# QUEENSLAND DEVELOPMENT CODE PART 3.7 – FARM BUILDINGS

Independent Review – Fire Engineering Report – Final

Issue – Final  
24/04/2015

WSP Buildings Pty Ltd has been appointed by Department of Housing and Public Works to undertake a technical desktop review of the Queensland Development Code (QDC) Part 3.7 – Farm Buildings

**Figure 12: Minimum separation distance of 6m would be necessary to minimise the risk of fire spread**

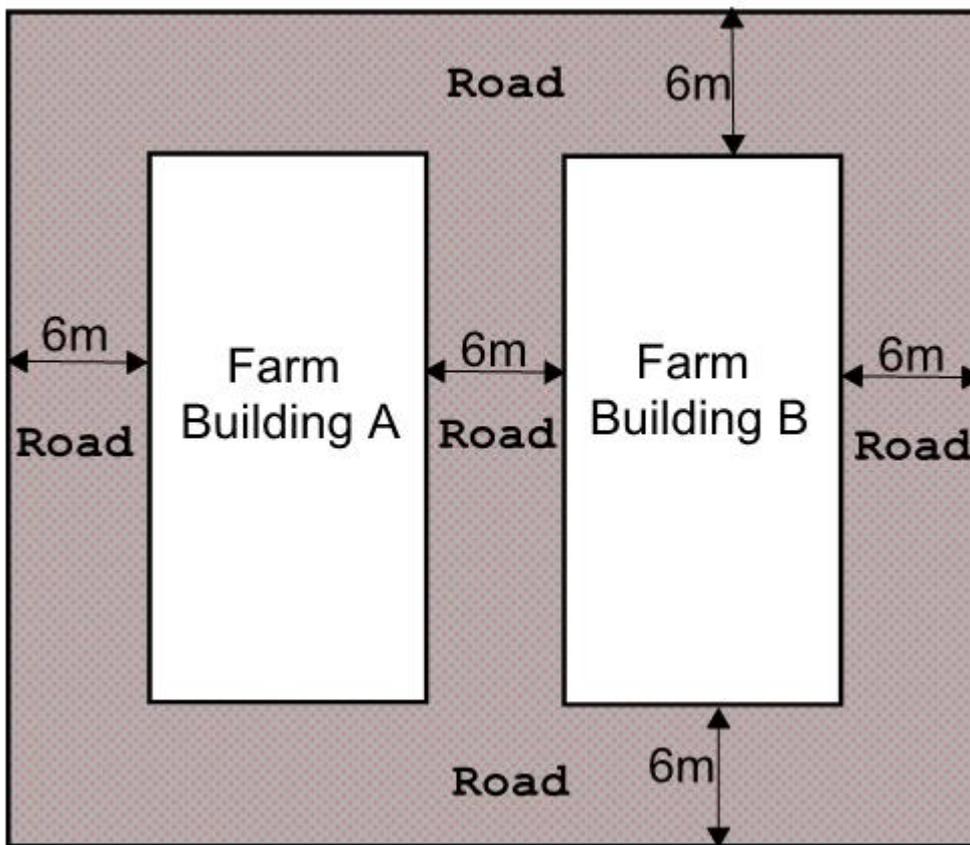
*Based on the above analysis, it is our view that a minimum separation distance of 6m would be necessary to minimise the risk of fire spread and also facilitate fire crew firefighting activities.*

*The below figure illustrates our view:-*
